The City of Burlingame

CALIFORNIA DRIVE ROUNDABOUT IMPROVEMENTS – **CITY PROJECT NO. 83920**

ADDENDUM NO. 1

February 5, 2018

STANDARD BUS STOP BUS PAD SECTION

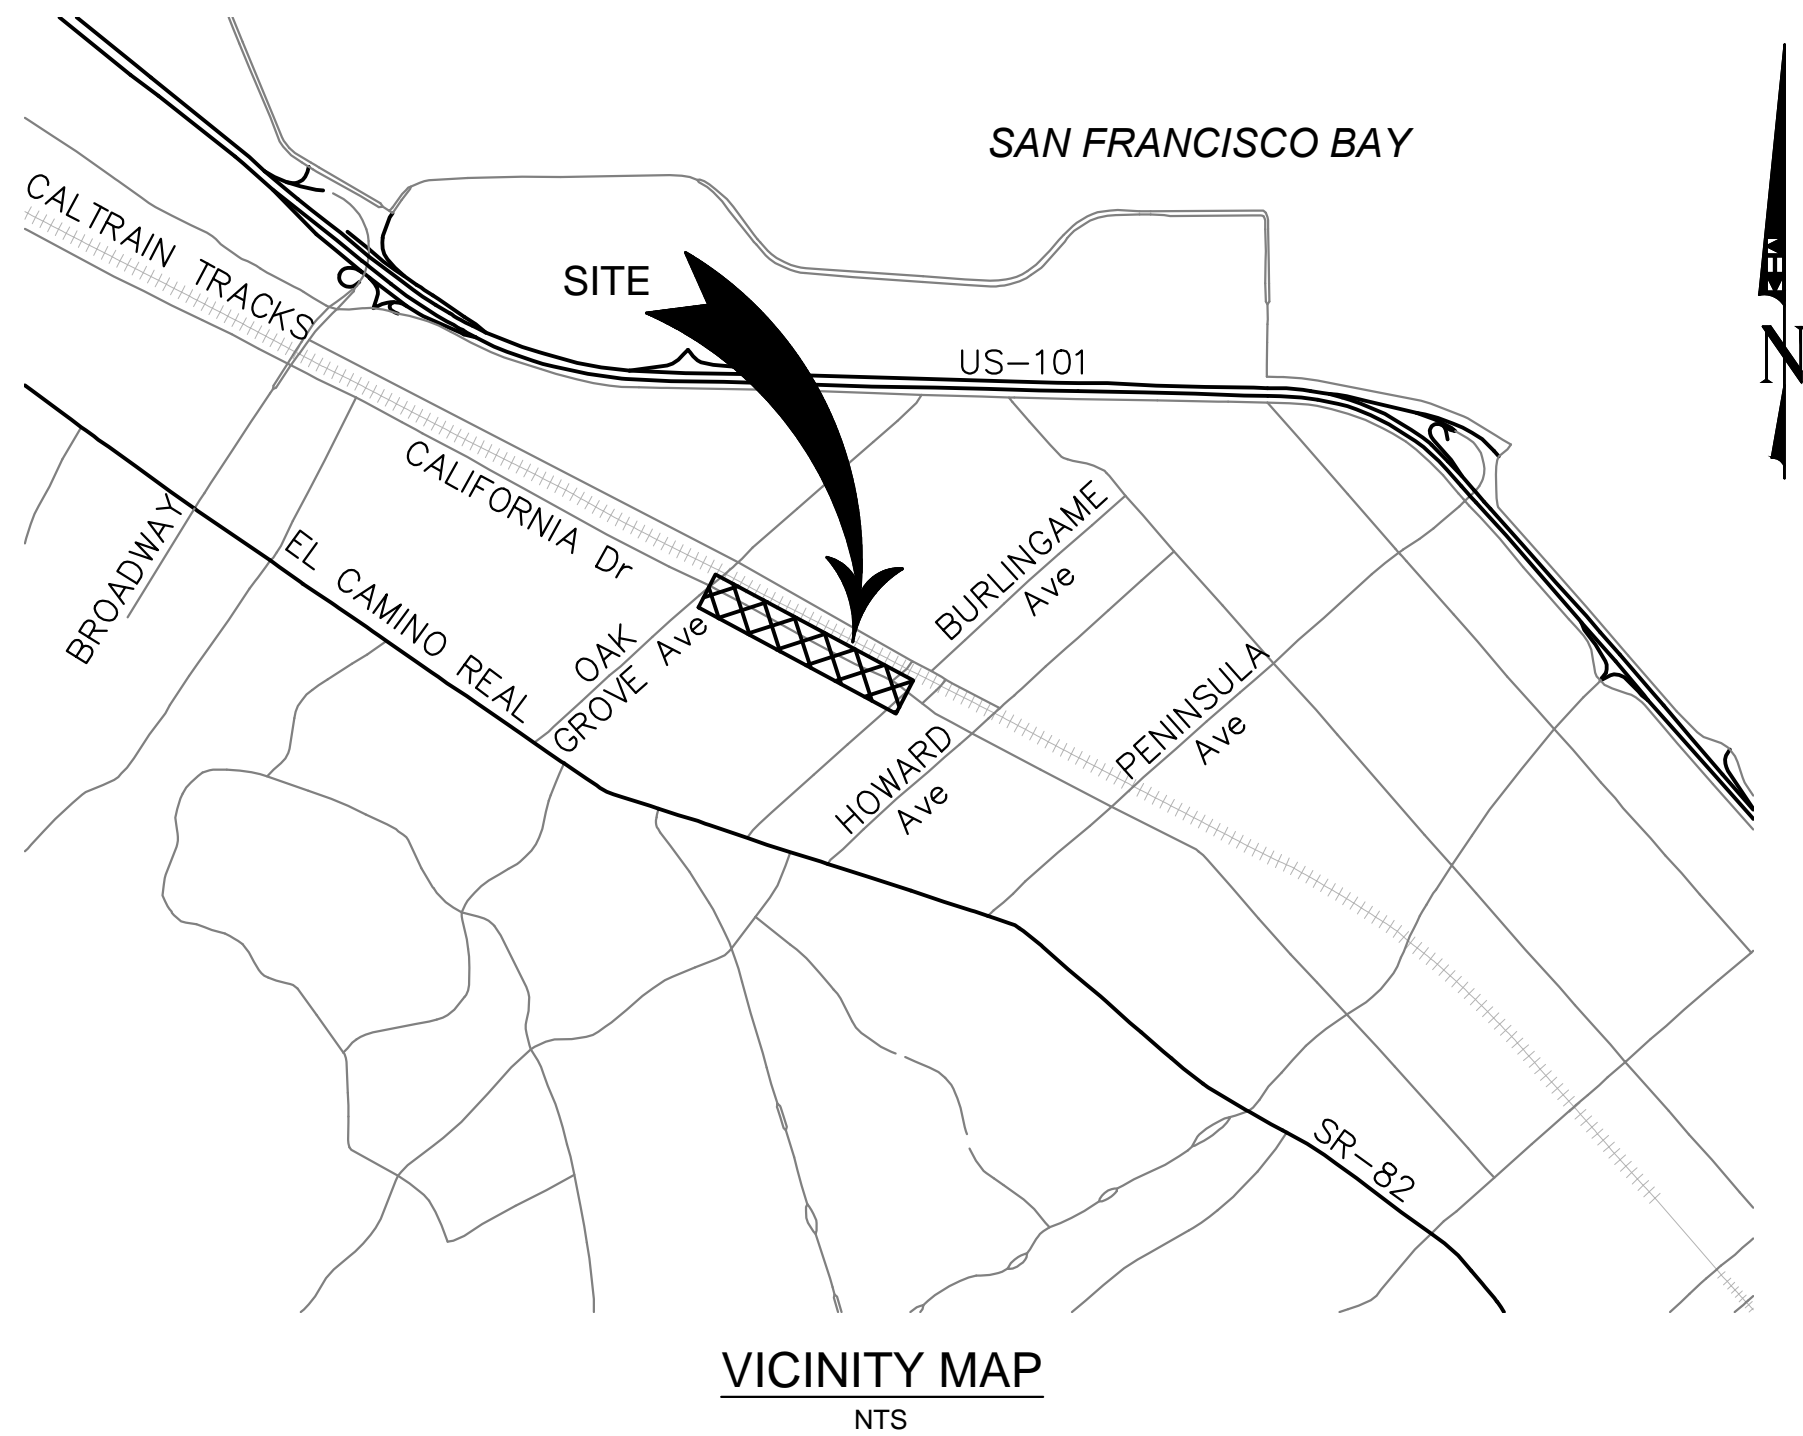
SamTrans standard detail "Standard Bus Stop Bus Pad Section" is included in the Appendix to these technical specifications. Construct bus pads in accordance with this detail.

SamTrans standard detail "Standard Bus Stop Bus Pad Section" is included in the Appendix to these technical specifications. Construct bus pads in accordance with this detail.
